DEVELOPMENT APPLICATION ASSESSMENT REPORT

Application Number:	DA2025/0603
---------------------	-------------

This development application seeks consent for the construction of an inclinator and associated works.

Figure 2: Development works within the foreshore building area - red shading).

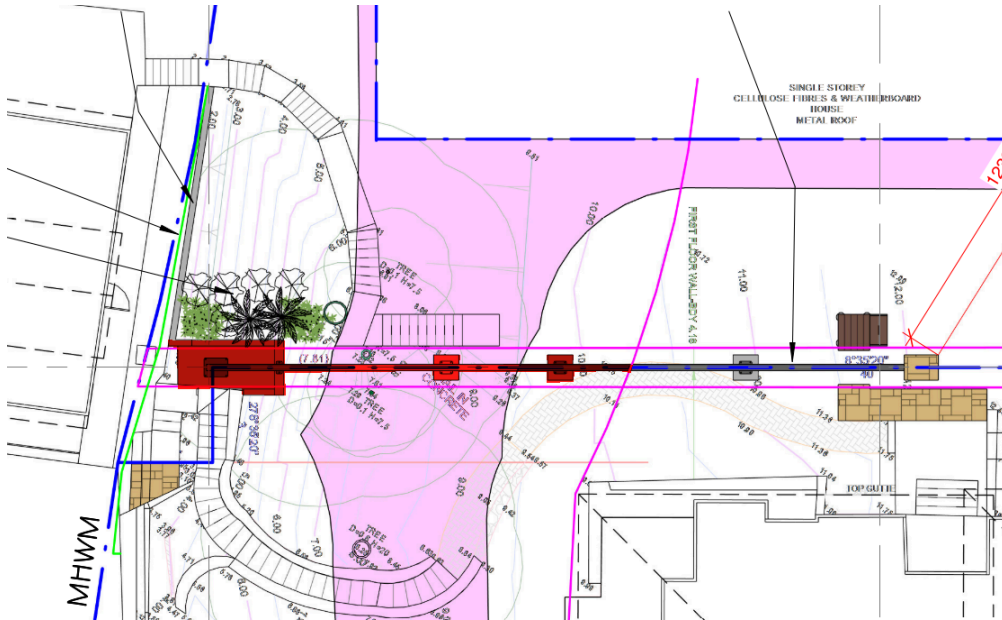
Proposed: A portion of inclinor and associated works i.e. excavation and retaining walls located within foreshore building area.

It is considered that the Applicant has demonstrated that there are sufficient environmental planning grounds to justify the contravention of Clause 7.8. The proposed inclinator will be situated wholly within an easement (E3 - see Figure 2) nominated for the purpose of an inclinator for access, with the portions located within the foreshore being the lower landing (L1), three (3) footings and rail. This portion of the element will extend into the foreshore area for a maximum length of 14.7 metres. To further support this, the inclinator is designed close to existing ground level, with majority of the rail being situated below 0.5m in height., mitigating visual impact.

Figure 3: Extract from submitted Architectural Plans indicating location and depth of excavation.

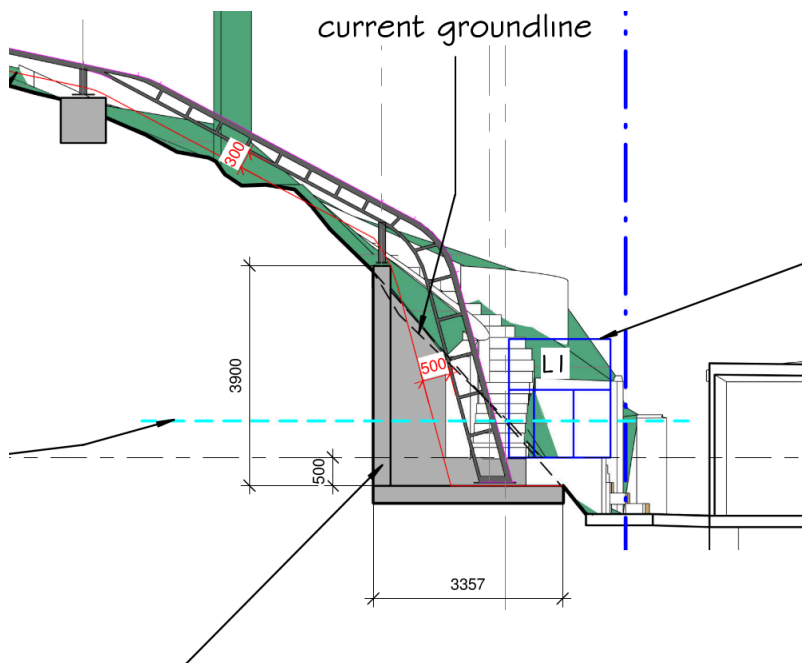
The proposed works will necessitate a depth of approximately 3.9 metres of excavation on the downhill side of the slope (landward of the existing cottage of No. 33 Sturdee Lane).

The excavation will be generally isolated to this area (as shown in the figure 3 for Landing L1, such excavation is a result of the steep topography occurring to the land in the location of Landing L1.

As discussed earlier within this Assessment Report, a Geotechnical Investigation was undertaken and submitted with the application. Such recommendations of the report will be included as conditions of consent.
